2.0 SAFETY LIMITS AND LIMITING SAFETY SYSTEM SETTINGS

ENCLOSURE 1 TO TXX-95213

GENERIC LETTER 88-16 - REMOVAL OF CYCLE-SPECIFIC PARAMETER
LIMITS FROM TECHNICAL SPECIFICATIONS

FIGURE 2.1-1b
UNIT 2 REACTOR CORE SAFETY LIMITS

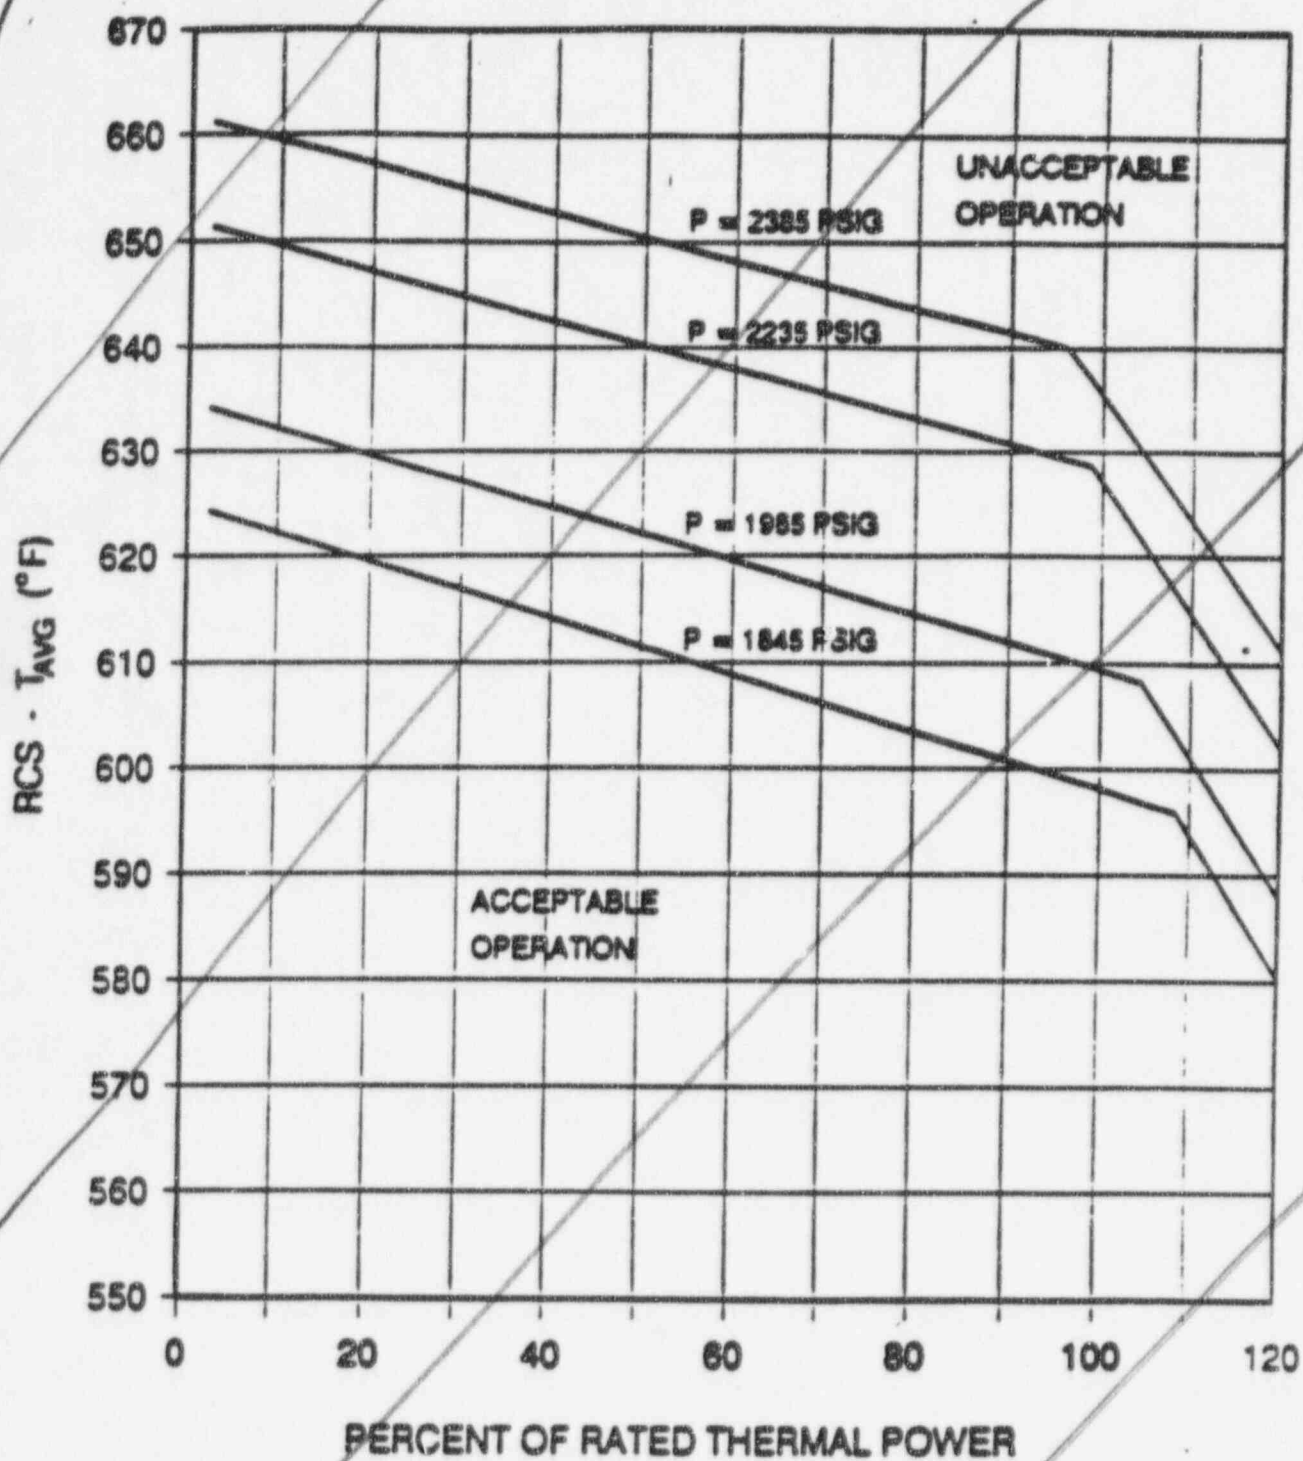
Delete

the Core Operating
Limits Report (COLR).

FIGURE 2.1-1a
UNIT 1 REACTOR CORE SAFETY LIMITS

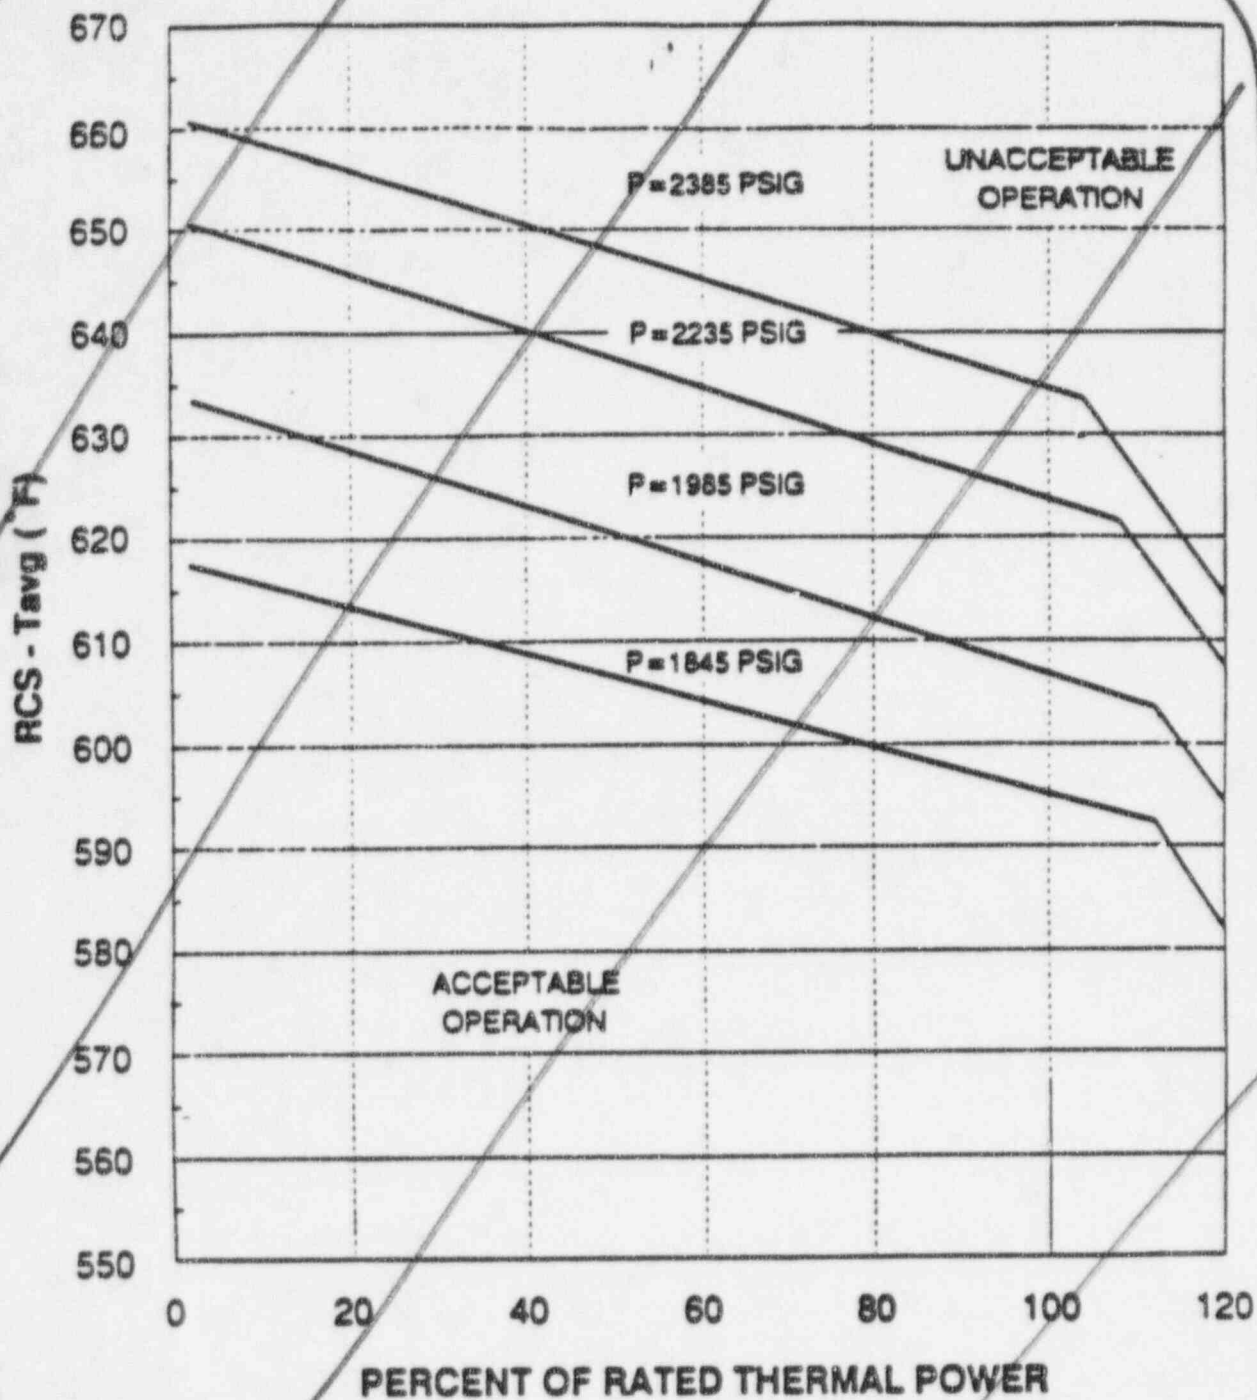
2.1.1 The combination of THERMAL POWER, pressurizer pressure, and the highest operating loop coolant temperature (T_{avg}) shall not exceed the limits shown in ~~Figure 2.1.1.2~~

Delete

The curves of ~~Figure 2.1.1~~ show the loci of points of THERMAL POWER, Reactor Coolant System pressure and average temperature below which the calculated DNBR is no less than the safety analysis limit value, or the average enthalpy at the vessel exit is less than the enthalpy of saturated liquid.
